Certification Labels – Incorrect Tire Size

Bulletin Type:	Recall
Bulletin #(s):	26V-554 USA 2026-415 Canada
Job Code(s):	9903664
Flat Rate(s):	9903664 - 0.3 Hr. Labor - Replace Certification Label

Publication Date:	September 2026
Make(s):	Jayco, Entegra Coach
Model(s):	Accolade, Accolade XL, Seneca, Seneca Prestige
Model Year(s):	2026 - 2027

Certification Label

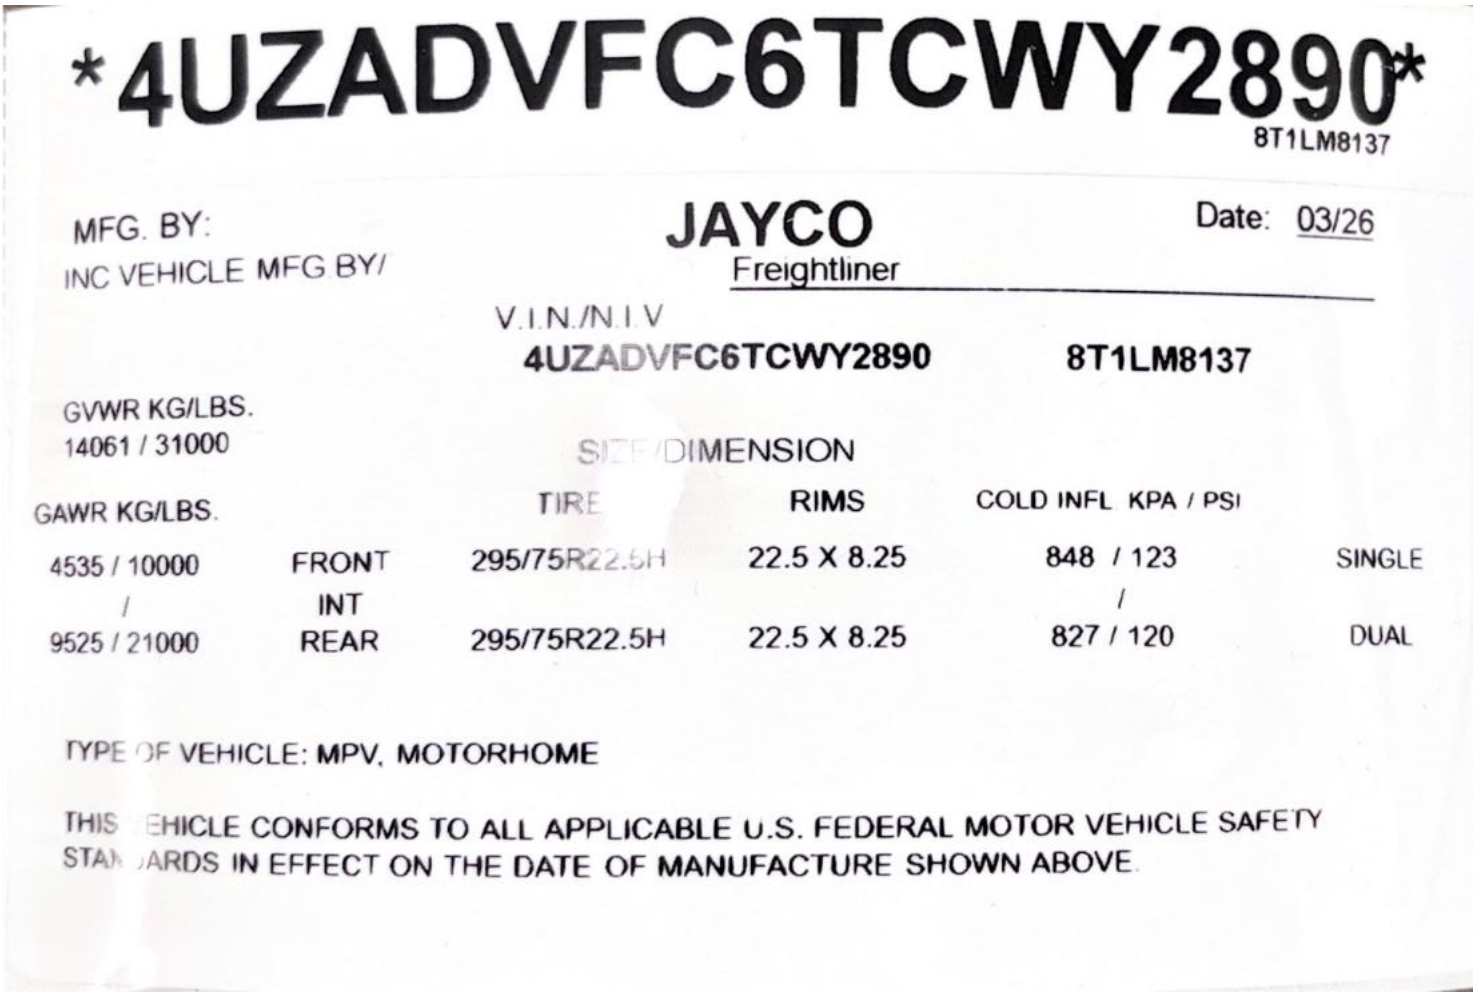
Incident:	Certification labels may have incorrect tire size information incorrect due to an internal data entry error. Labels show incorrect tire size of 275/80R/22.5 instead of 295/75R/22.5H.
Affected Units:	Certain 2026 – 2027 Jayco Seneca, Seneca Prestige & Certain 2026 – 2027 Entegra Coach Accolade & Accolade XL
Part:	Part: Certification Label enclosed in owner/dealer notification letter
Misc. Tools & Supplies:	Isopropyl alcohol Shop rag
Parts Return Information:	N/A

The certification label below is only an example of the label you are to replace.

GAWR KG/LBS.		TIRE	RIMS	COLD INFL KPA / PSI	
4535 / 10000	FRONT	295/75R22.5H	22.5 X 8.25	848 / 123	SINGLE
/	INT			/	
9525 / 21000	REAR	295/75R22.5H	22.5 X 8.25	827 / 120	DUAL
